Bearing Wear Monitoring System update

SL2013-569/HWC
May 2013

Owners and operators of MAN B&W two-stroke marine diesel engines. Type: MC/MC-C/MC-S, ME/ME-C, and ME-B

A BWM system update lowers the response time from 46 min. to 9.5 min.

Fig. 2: Sequence of alarms

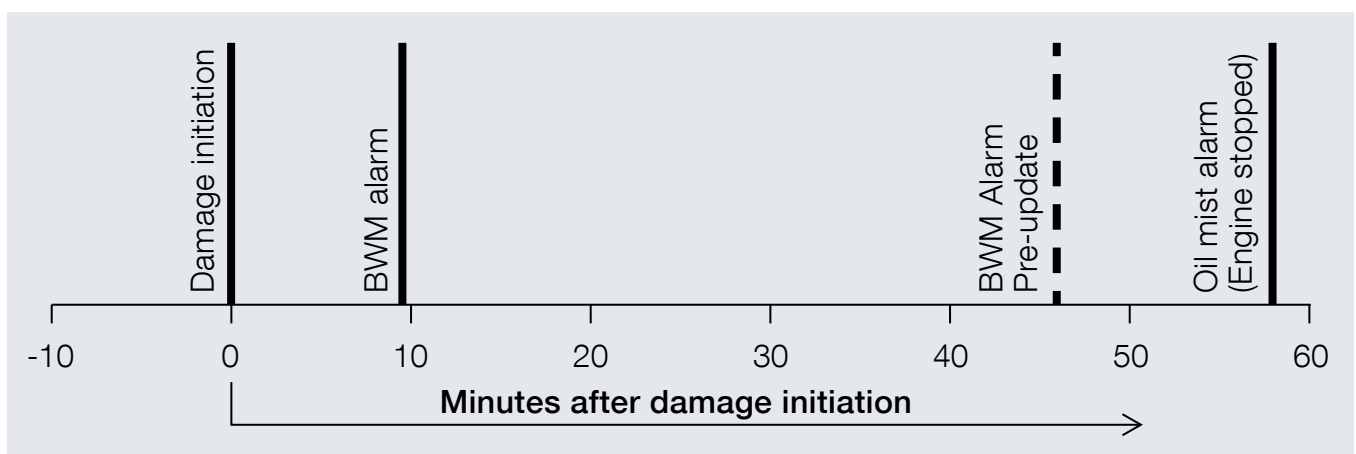
- a BWM system of the early type (pre-update) would have set off an alarm 46 min. after the initial stage of the seizure.

Fig. 2 shows the alarm times of an updated BWM system installed and of an earlier type system (pre update).

Considering the response time of the pre-update type BWM (46 min.) and of an updated type BWM (9.5 min.), the updated system provides a significantly better protection against severe bearing damage.

MDT recommends that owners of engines fitted with pre-update BWM systems arrange for an update.

If the ability to detect rapid wear cannot be assured by these procedures, MDT recommends owners to contact the maker directly (ref. Encl. 1). The maker can relate to the following criterion: Systems in compliance with MDT specification No. 3091686-8.2 or later are capable of early detection of rapidly developing damage.

Note that this update introduces connection of the BWM system to the automatic slow-down/load reduction function of the main engine safety system.
